Porsche Carrera Cup France 2022

Note Technique 04/2022

BOUCHON DE VIDANGE D'HUILE

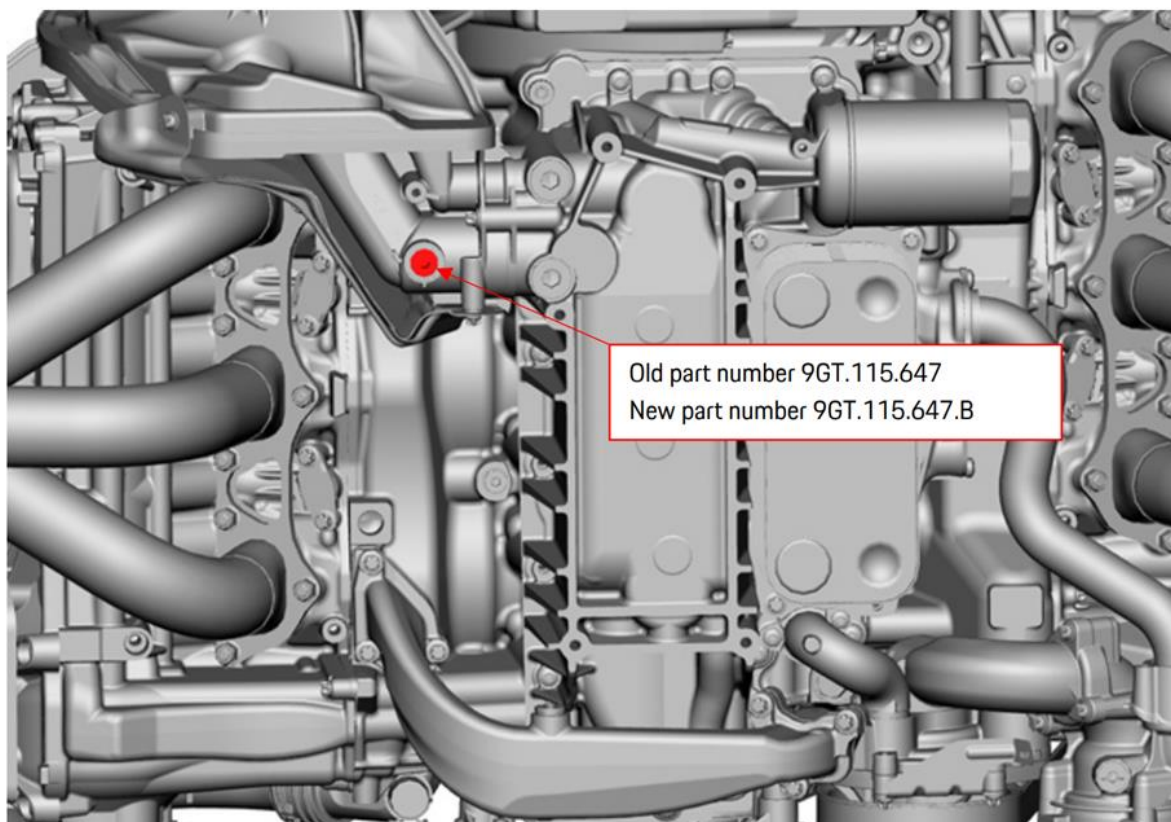
Porsche Motorsport vous informe que desserrer le bouchon de vidange d'huile lorsque le réservoir est chaud peut endommager ce dernier. Il est par conséquent fortement recommandé de desserrer le bouchon de vidange 9GT.115.647 lorsque le réservoir d'huile est froid (<30°C) et de le remplacer par la nouvelle référence 9GT.115.647.B (serré à 20 N.m) dès votre prochaine vidange.

Porsche Motorsport informs that loosening the oil drain plug when the oil tank is hot can damage the oil tank. It is therefore strongly recommended to loosen the built-in oil drain plug 9GT.115.647 when the oil tank is cold (<30°C) and replace it with the new screw 9GT.115.647.B (tightening torque 20 Nm) at the earliest opportunity.

Si vous utilisez un réservoir d'huile de référence 9F1.115.373.D, il n'est pas nécessaire de changer le bouchon de vidange. (les millésimes 2021 et 2022 étant équipés de réservoirs d'huile référencés 9F1.115.373.A ou 9F1.115.373.B d'origine)

If an oil tank with part number 9F1.115.373.D is used, changing the oil drain plug is not necessary (cars of model years 2021 and 2022 have built in oil tanks with part number 9F1.115.373.A or 9F1.115.373.B ex works).
